98V-192 (01)

SUBJECT OF RECALL : SPEED CONTROL CABLE

SUBJECT: Safety Recall 98S22 - Certain 1998 Model Year F-Series Trucks -
Speed Control Cables

SPEED CONTROL CABLE LOCKING PIN

FIGURE 1

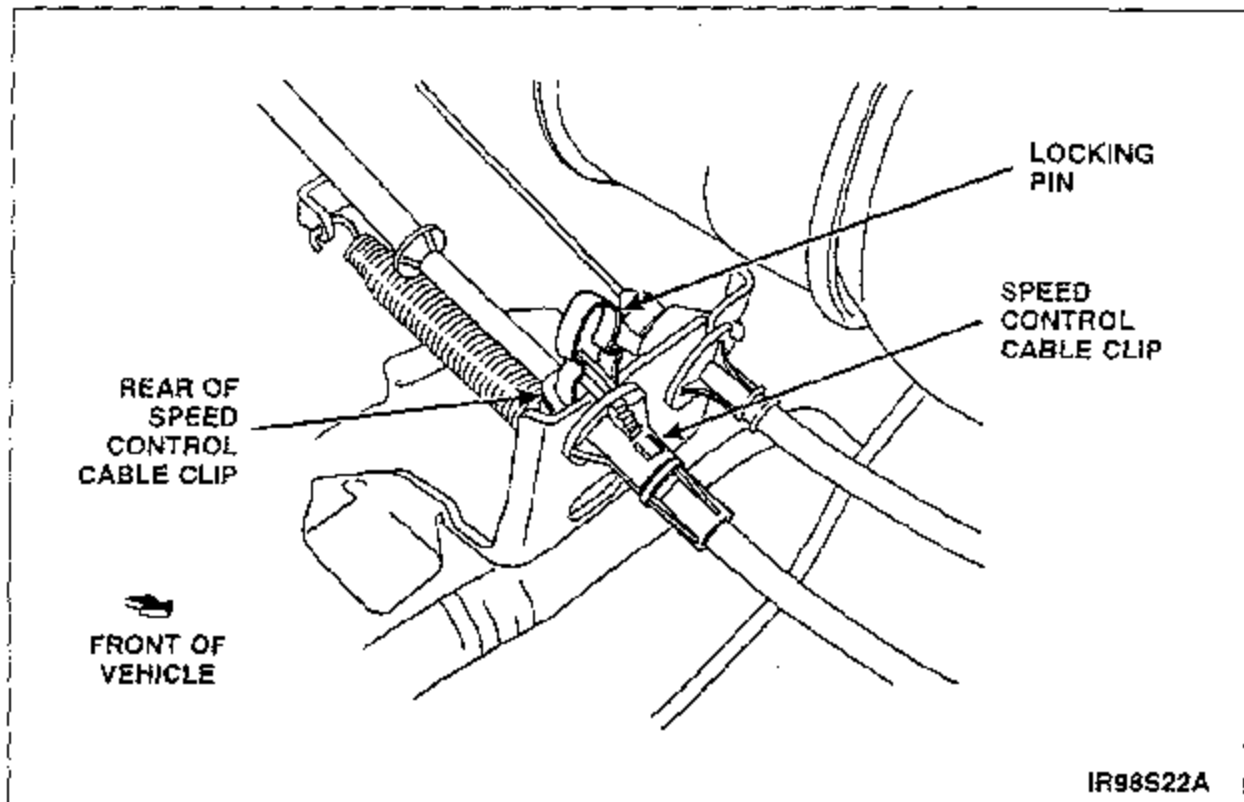
1. Open hood.
2. Remove shield covering throttle body assembly.
3. Locate accelerator cable bracket on intake manifold.
4. Install secondary retaining clip on rear of speed control cable clip. See Figure 1.

FIGURE 2

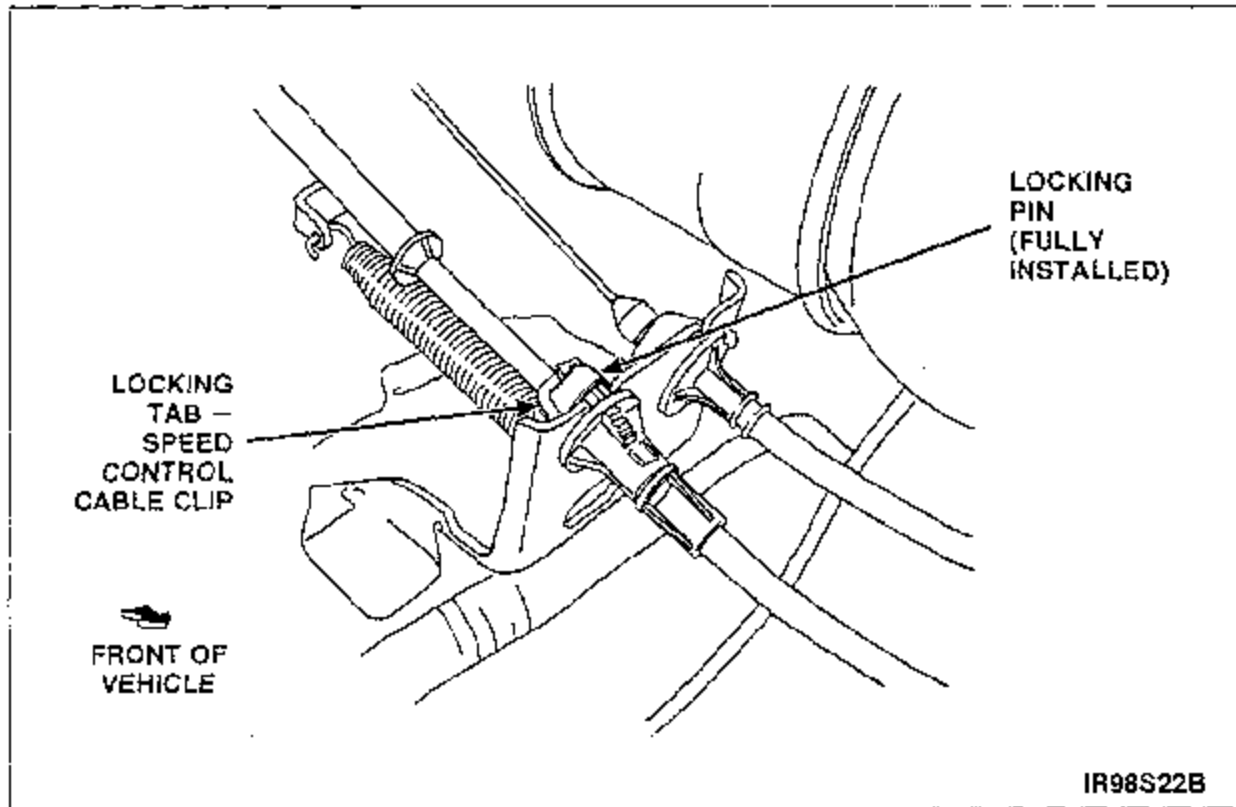
5. Make sure locking pin is spreading locking tabs on speed control cable clip. See Figure 2.
